Zoning
CITY OF AUSTIN
RECOMMENDATION FOR COUNCIL ACTION

SUBJECT: C814-01-0038.02 - Parmer/Walnut Creek PUD Amendment #2 - Conduct a public hearing and approve an ordinance amending Chapter 25-2 of the Austin City Code by rezoning property locally known as 1200-1210 West Parmer Lane (Walnut Creek Watershed) from community commercial (GR) district zoning and planned unit development (PUD) district zoning to planned unit development (PUD) district zoning. Zoning and Platting Commission Recommendation: To grant planned unit development (PUD) district zoning with conditions. Applicant: Edgar and Linda Perry, Exxon Corporation (Sandra L. Heysinger). Agent: McLean & Howard, L.L.P. (William P. McLean). City Staff: Sherri Sirwaitis, 974-3057.

ZONING CHANGE REVIEW SHEET

CASE: C814-01-0038.02

**PRELIMINARY
LAND USE PLAN**

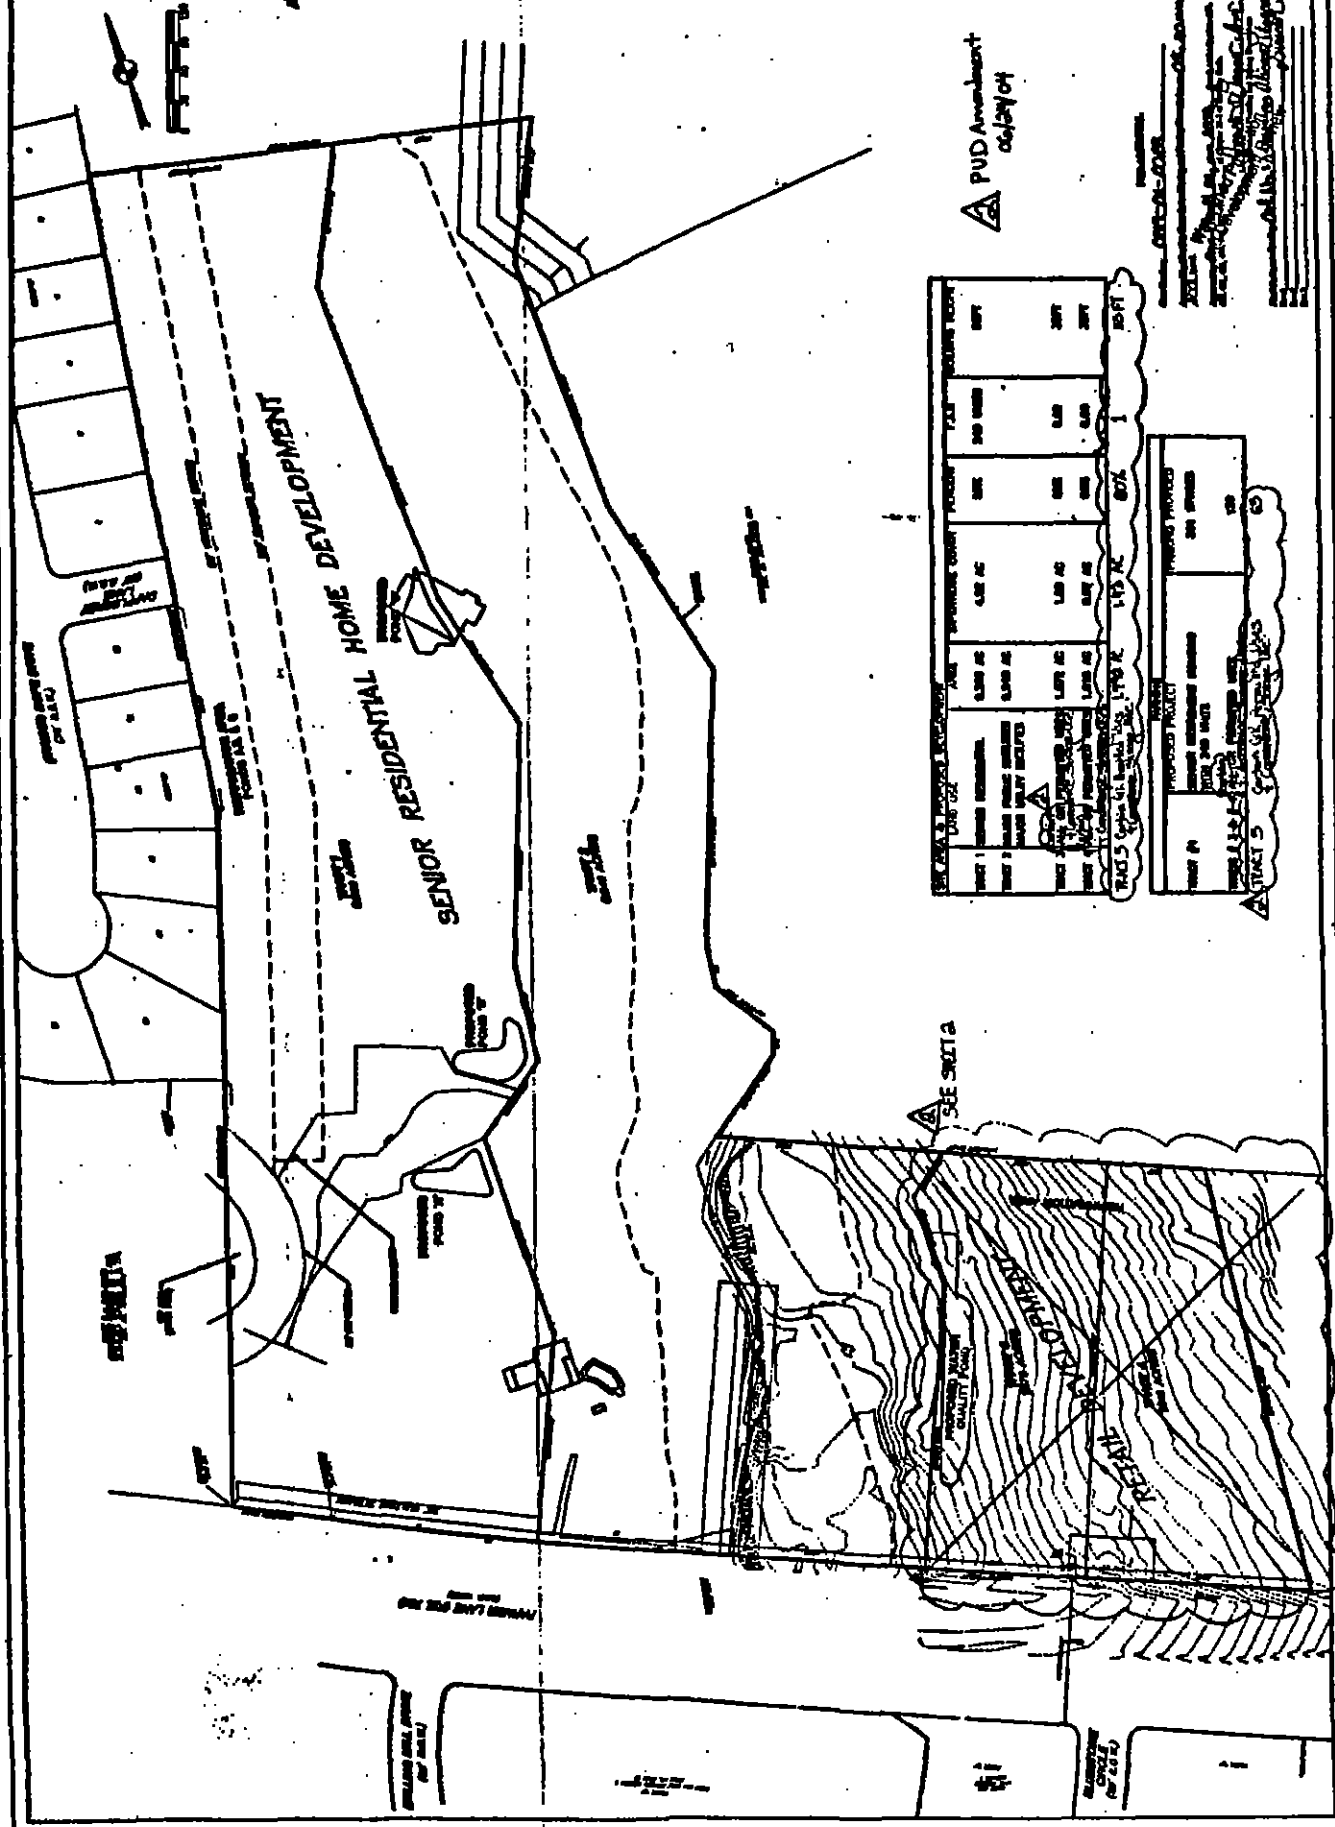
The revised land use table identifies the allowable uses for Tract 5 as "Certain GR permitted uses". Please note that this notation would NOT include Convenience Storage, since Convenience Storage is never a permitted use in the GR zoning district.

The letter states that Convenience Storage would have "superior design standards" however the design standards proposed do not seem superior to the minimum standards required for any convenience storage facility that is subject to compatibility regulations.

The proposed 25-foot vegetative buffer described in the land use plan, does not seem that significant if the developer is permitted to simply have 25-feet of lawn area between the parking/building and the street. The proposed vegetative buffer should spell out more stringent and aesthetically pleasing landscaping requirements than simply "vegetative buffer" which would be satisfied by any type of vegetation.
